Cannondale Motorsports Service Bulletin

BULLETIN : SB02-009

MODELS : All 2002 ATVs and Motorcycles

SUBJECT : Stator output wire shielding

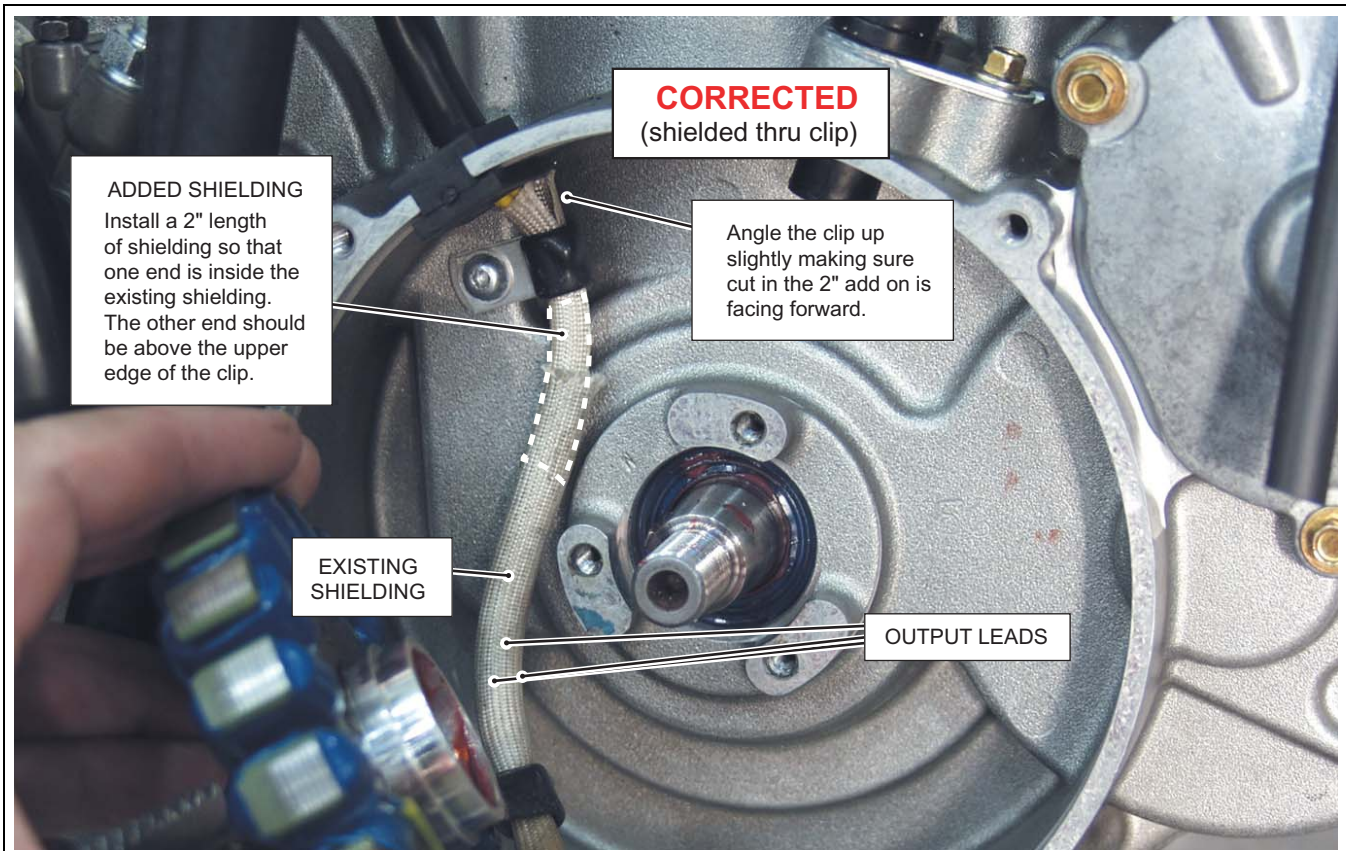
CONDITION : The stators of both ATV and Motorcycle units produced prior to 5/16/02 may have an incorrect length of shielding of the stator output leads. Stator were received from our vendor in the period prior to 5/16/02 with varied shielding lengths. A short length of shielding result in the stator output leads passing through the clip, unshielded. See "Incorrect" on page 2.

Unshielded leads passing through the stator clip increase the chances that crankcase heat and wire vibration will produce damage the stator output lead insulation. When this happens, the leads can short circuit directly to ground through contact with the clip or short circuit between the individual output wires. This may result in a failure of the vehicle charging system. If the charging systems fails to supply voltage to the rectifier/regulator during engine operation, the battery voltage can drop triggering the engine management power latch to drop supply to the engine control unit (ECU). When this happens, the engine will shut down.

INCORRECT

CORRECTED

4. With the stator installed, carefully inspect the installed stator output leads where they pass through the stator clip. The length of woven shielding should extend above the top of the clip. Refer to the illustrations "Incorrect" and "Corrected" on page 2 of this bulletin. Move the stator output lead at a point above the crankcase seal exit to make sure any small movement present does not change the proper position of the shielding through the clip.

10. Install the add-on length of shielding (2"). Make a lengthwise cut in the shielding and wrap it around the output wires. Slide the lower end of the cut shielding into the existing "un-cut" shielding. Slip the open end of the clip over the "add-on" shield and install the clip with the loop facing out (away from the crankcase). Be sure to install the washer with the clip bolt. See "Corrected" on page 2.
